Focused Review of Specific Remediation Issues

An Addendum to the Remediation System Evaluation
for the
Homestake Mining Company (Grants) Superfund Site, New Mexico

Final Report
December 23, 2010

Prepared by US Army Corps of Engineers
Environmental and Munitions Center of Expertise
For US Environmental Protection Agency, Region 6

Figure 1b. Well Locations

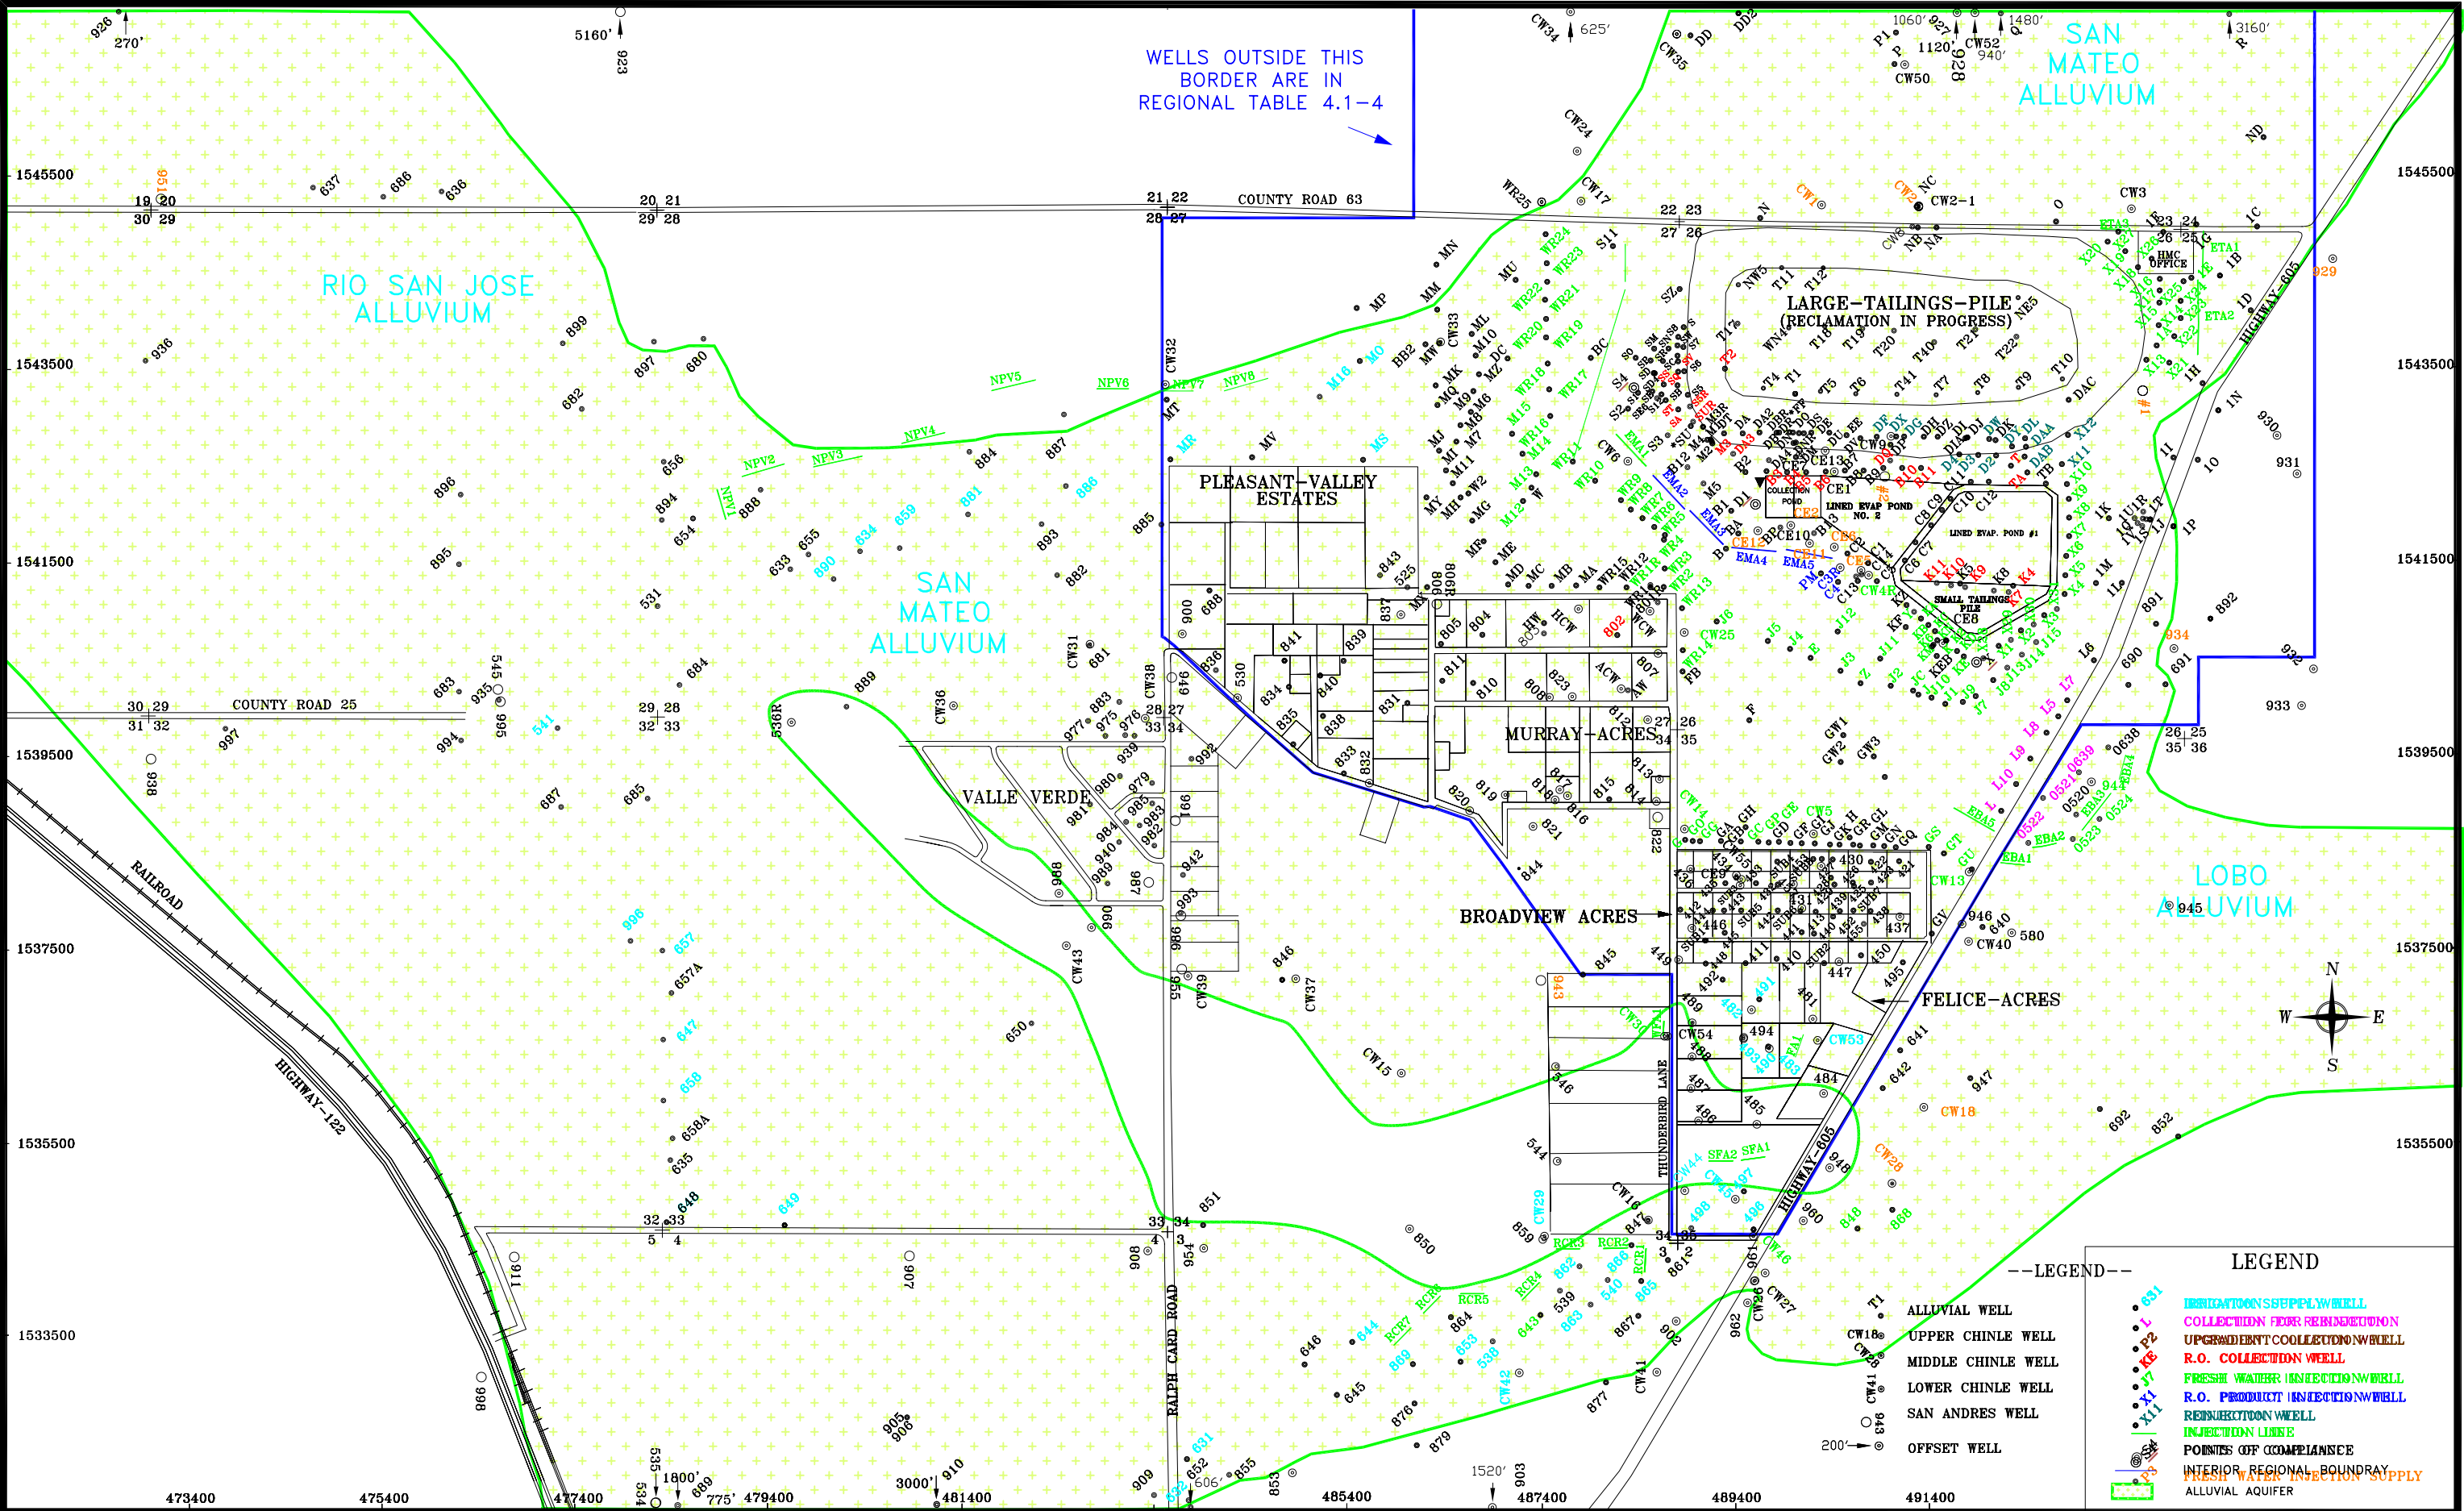
89	EPA	Figure 1	9	Add a figure that clearly indicates monitoring well locations. I can not identify monitoring wells referenced in the report on this figure.	Concur	We will attach a separate file in 11x17" format such that it can be more easily read.
90	EPA	Figures	11	Please check the labels on the x and y axes – the dates and other units are not correctly located or easy to read. Please reformat figures to allow for accurate reading of the x and y values.	Concur	Text will be revised.
91	EPA		17	last paragraph, 3 rd sentence. Change ‘has’ to ‘have’ and change figure to “Figure 15 in the same sentence.	Concur	Text will be revised.
92	EPA		18	paragraph in the middle of the page regarding additional testing of oxidation-reduction potential. Please elaborate on the types of add'l testing that would be necessary and how the data should be interpreted.	Concur	We will elaborate to indicate that downhole ORP and pH measurements would be useful to assessing the likely state of the U in the pile and the impacts from the flushing program on the stability of the U.

9. page 7, section 2.2.1, first sentence. Change ‘human’ to humans”
10. page 7, section 2.2.2, first sentence. Change ‘and’ to ‘can’.
11. page 9, Figure 1. Add a figure that clearly indicates monitoring well locations. I can not identify monitoring wells referenced in the report on this figure.

Figure 1 at p. 9 is not sufficiently detailed to identify the location of the wells of concern discussed in this section, as well as other sections of the Report. Figure 1 does not identify the locations of wells DD or S11 or the flow paths of concern on the west side of the tailings pile.

Neither Figure 1 nor other figures identify the location of fault zones in the project area, the extent of the alluvial aquifer, or other geologic features that might influence ground water flow paths on the west side of the large tailings pile. The “scanned” well location maps posted by the RSE contractor team on the HMC RSE Quickr website provide additional detail but are not clearly integrated into the DRSE Report.

The DRSE Report should be supplemented to address the location of well DD and its associated flow path within the footprint of proposed evaporation pond 3 (neither well DD or EP3 are identified on Figure 1) and the challenges to investigation and remediation of the ground water with rising uranium content in the well DD/well S11 area north and west of the large tailings pile.

Figure 3. Well X Uranium Concentration Trends.

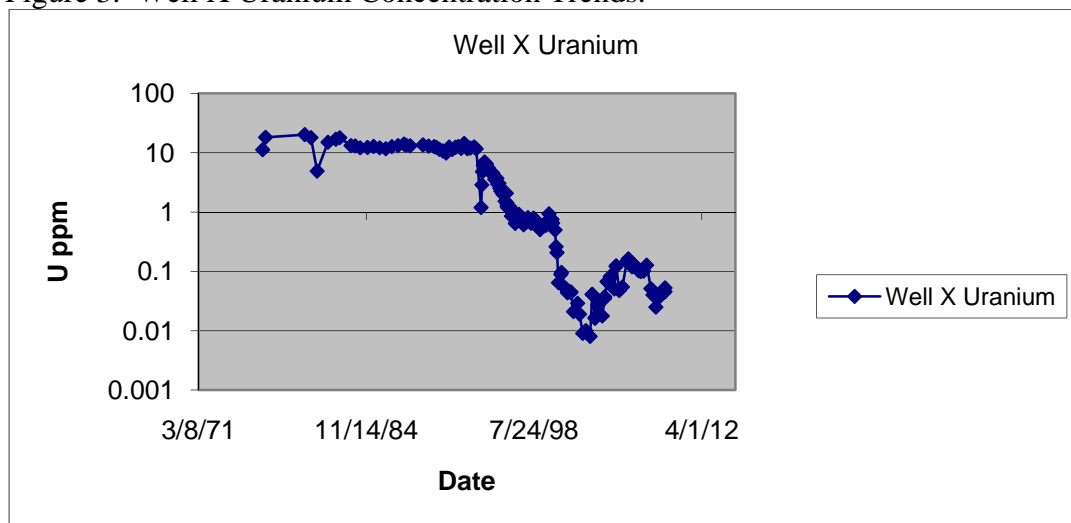
53	NMED	2.3	7	The last sentence should refer to figure 2 instead of figure 1.	Concur	The text will be corrected.
54	NMED	3.2	8	Please move x-axis label to the bottom of figures 3, 4, and 8.	Concur	The readability of the charts will be improved in several ways.

Figure 3 on p. 8 illustrates the downward uranium trend in well X.

Review of the uranium concentration trend for well X in Figure 3 shows that the uranium concentration in the well remained relatively steady for several decades before a steep drop in uranium concentrations was detected.

Figure 3 shows the drop in uranium concentration occurring after the construction of EP1 and the injection wells – including the "1993 J-line" of injection wells – along the south perimeter of EP1 and the small tailings pile. Figure 1 shows well X to be in such close proximity to injection wells that the symbols for the two are touching on the figure.

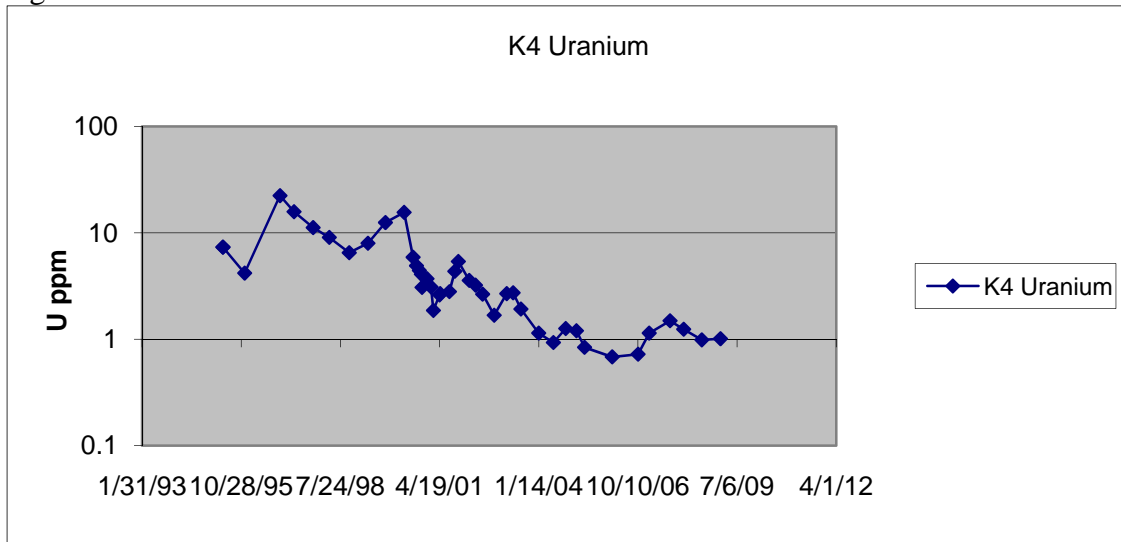
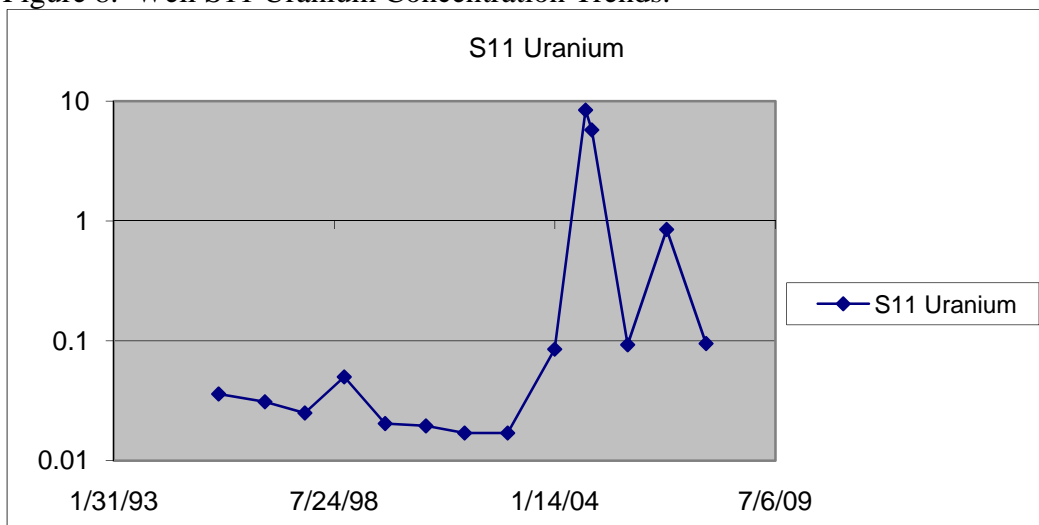
2.3	The last sentence should refer to Figure 2 instead of Figure 1.
3.2	Please move x-axis label to bottom of figures 3, 4, and 8.
3.6	The San Andres aquifer is an important municipal water supply source to the nearby major population centers of Grants, Milan, and Bluewater, as well as to residents using private wells within the impacted subdivisions south of the Site. NMED asserts that routine and focused monitoring of this aquifer, both upgradient and downgradient of the Site, should be included within the Remedial System to better support an assertion of no contaminant impacts to this aquifer from the overlying Site-contaminated aquifers.

Figure 13. Well DD Uranium Concentration Trends.

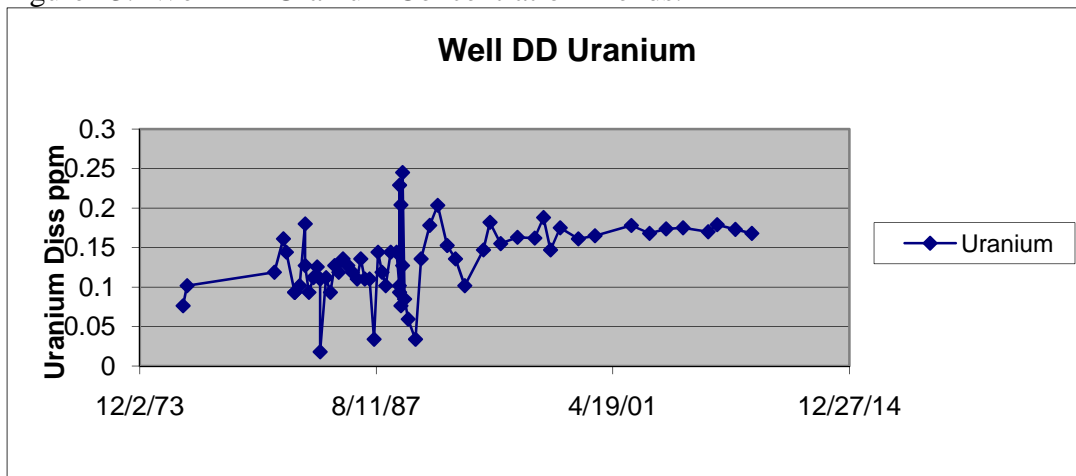
The DRSE Report shows a rising uranium trend in well DD in Figure 13 which results in a doubling of the uranium concentration in that well from the initial data point, which appears to be from the 1970s. The DRSE Report recommends the adoption of efforts to “further evaluate capture of contaminants west of the northwestern corner of the large tailings pile.”

Figure 14. Uranium Concentrations in Large Tailings Pile

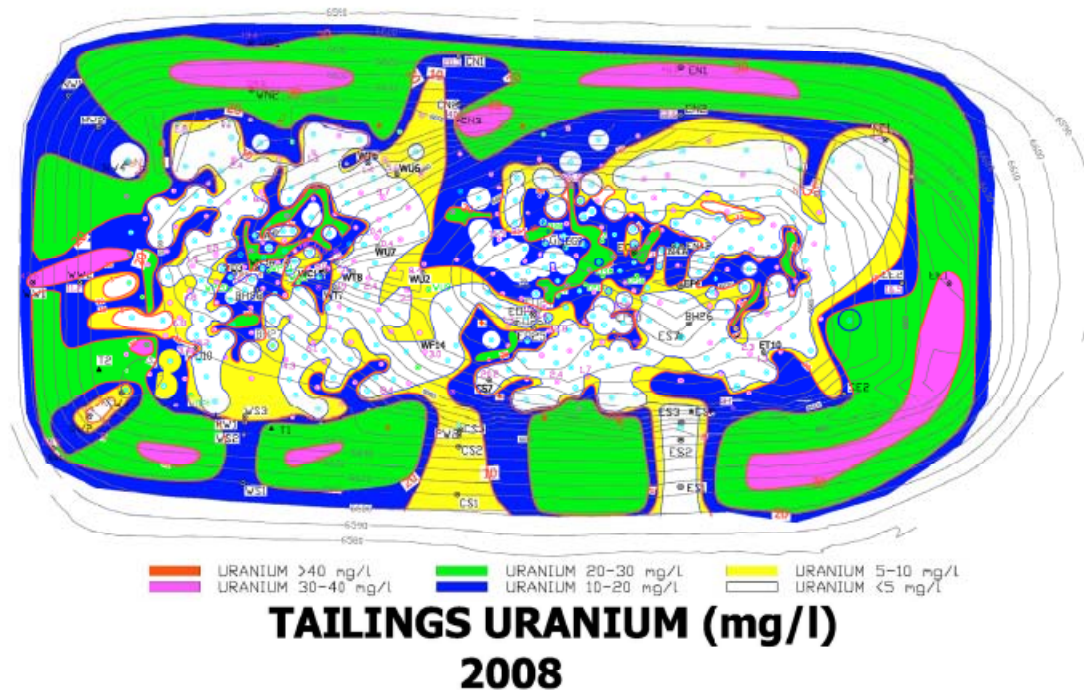
34	HMC	4 & Fig. 14	17	<p>The flushing of the large tailings pile is discussed and Figure 14 is used to show the 2008 uranium concentrations in the tailings. Although the ACOE uses this figure to show the variability of uranium in the pile and illustrate their belief that the flushing has not been effective, HMC believes that the flushing has been effective at removing uranium mass. This is demonstrated by comparing the 2000 and 2009 maps for uranium in the tailings pile, which shows that a significant amount of uranium has been removed. See also HMC's response to Recommendation No. 2 for additional evidence of the effectiveness of the flushing and extraction program. Below is the 2000 uranium concentration map for the tailings pile showing uranium concentrations exceeding 30 mg/L in much of the pile. Also below is a map of the 2009 uranium concentrations in the pile, which illustrates the significant reduction in concentrations resulting from the flushing and extraction program. For 2009, approximately 67.5 percent of the west side slime area has uranium concentrations less than 5.0 mg/L, and 45.5 percent of the same area has concentrations lower than 2.0 mg/L.</p>	Non-concur	<p>The flushing program has made some progress, as the report acknowledges. As discussed above and in the report, the concern is that the long screens of the monitoring points makes it likely that injected water has impacted the monitoring point, but that the ambient concentrations may be much different. The map was meant to illustrate the wide variations in concentrations at closely spaced points such that the flushing is clearly not uniform.</p>

Section 4.1 and Figure 14, Flushing of Large Tailings Pile; page 17. The flushing of the large tailings pile is discussed and Figure 14 is used to show the 2008 uranium concentrations in the tailings. Although the ACOE uses this figure to show the variability of uranium in the pile and illustrate their belief that the flushing has not been effective, HMC believes that the flushing has been effective at removing uranium mass. This is demonstrated by comparing the 2000 and 2009 maps for uranium in the tailings pile, which shows that a significant amount of uranium has been removed. See also HMC’s response to Recommendation No. 2 for additional evidence of the effectiveness of the flushing and extraction program. Below is the 2000 uranium concentration map for the tailings pile showing uranium concentrations exceeding 30 mg/L in much of the pile. Also below is a map of the 2009 uranium concentrations in the pile, which illustrates the significant reduction in concentrations resulting from the flushing and extraction program. For 2009, approximately 67.5 percent of the west side slime area has uranium concentrations less than 5.0 mg/L, and 45.5 percent of the same area has concentrations lower than 2.0 mg/L.

Figure 15. Uranium Concentrations in Select Wells in a) Western Large Tailings Pile and b) Eastern Large Tailings Pile.

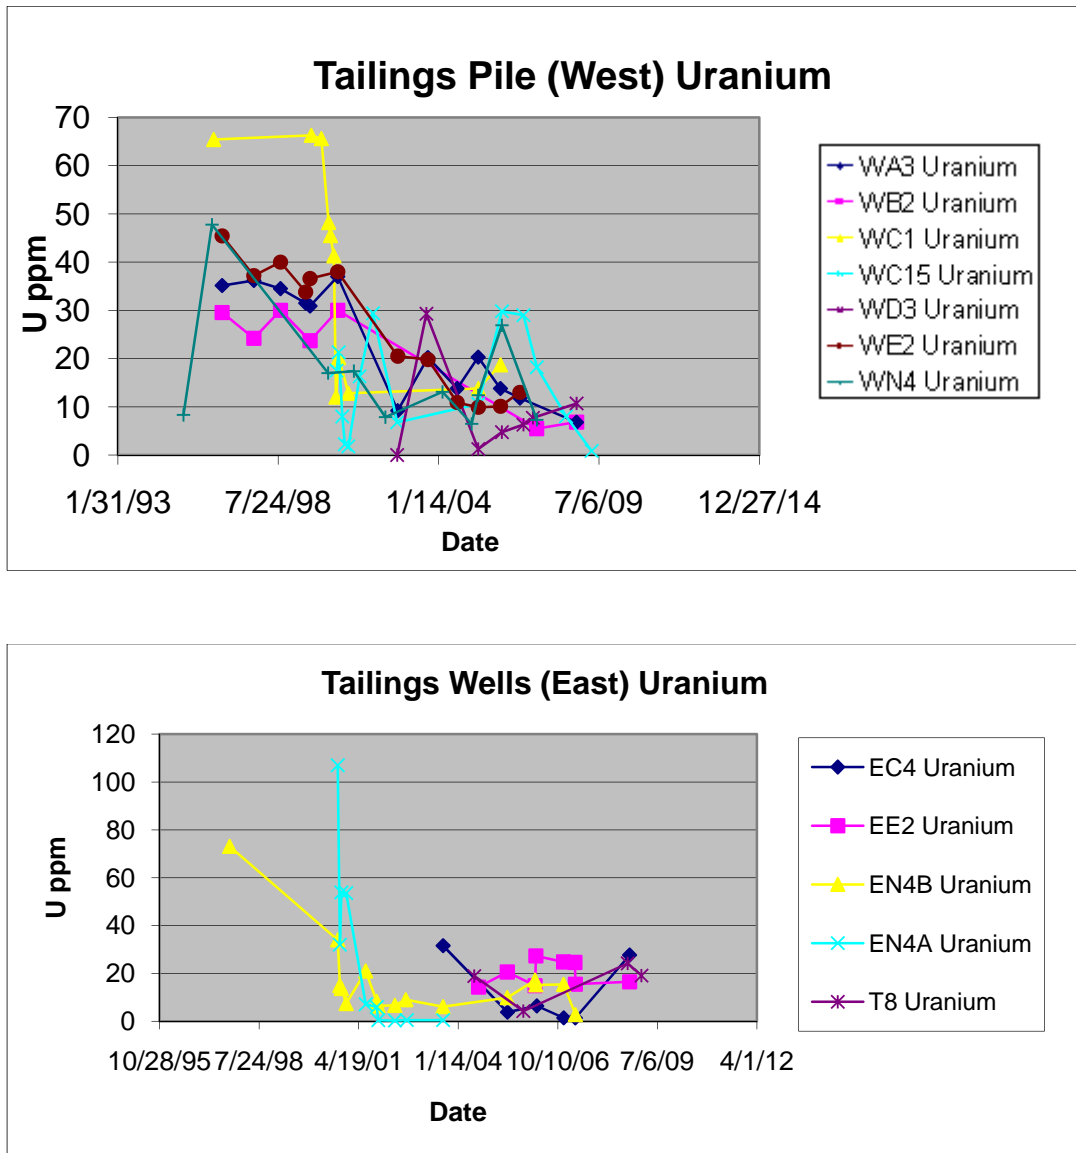
57	NMED	4.1	18	Tailings in Figure 15 is misspelled.	Concur	Chart heading will be corrected.

13. page 17, last paragraph, 3rd sentence. Change ‘has’ to ‘have’ and change figure to “Figure 15 in the same sentence.
14. page 18,. paragraph in the middle of the page regarding additional testing of oxidation-reduction potential. Please elaborate on the types of add’l testing that would be necessary and how the data should be interpreted.
